Service Bulletin

Eaton® Heavy Duty – Models 33 thru 76 Tapered Shaft Nut Torque Specifications

No. 980901
September 1998
(Replaces No. 980601 June 1998)

Tapered Shaft Models 33 thru 64 Compatible with ISO 3019/1 (SAE-J744) Specifications

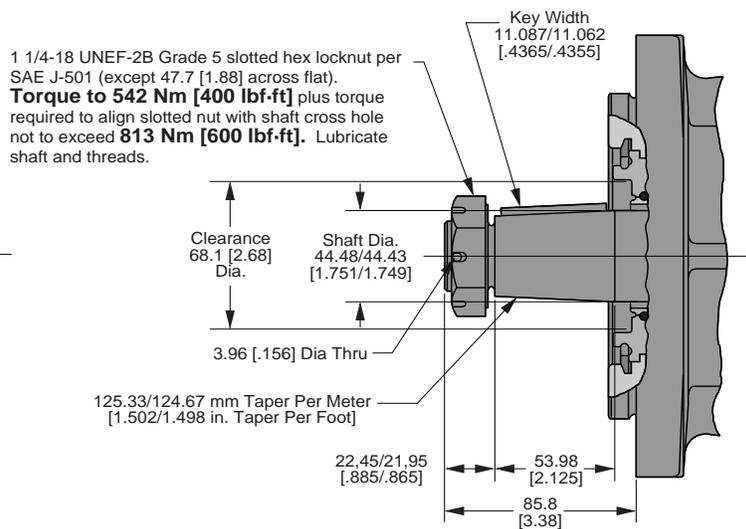
Be advised that the shaft nut torque specifications on the Heavy Duty Series Models 33 thru 76 has been increased. Note the new torque values listed below.

Tapered Shaft Yoke Puller

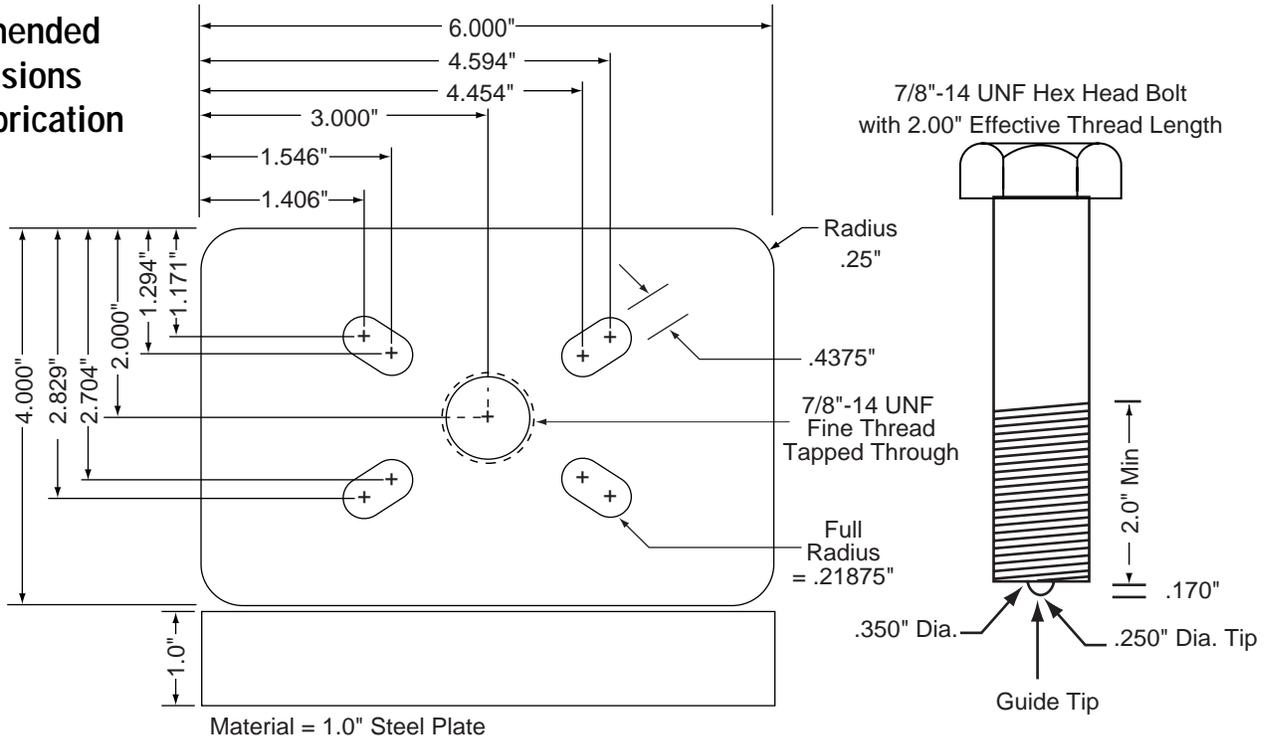
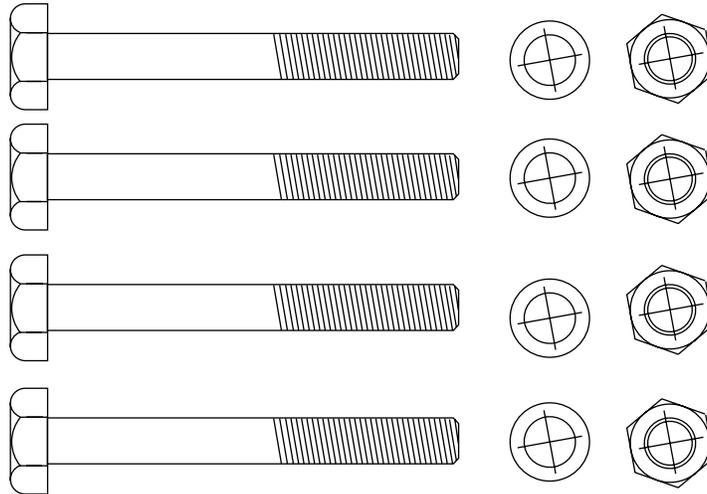
This Service Bulletin replaces previous versions as we discovered some errors in the dimensions referenced on the Tapered Shaft Yoke Puller Tool. Plus we reduced the required effective thread length size of the 7/8" bolt. We found that 2" effective thread length works fine and this type of bolt is more easily sourced. We apologize for any inconvenience these errors may have caused.
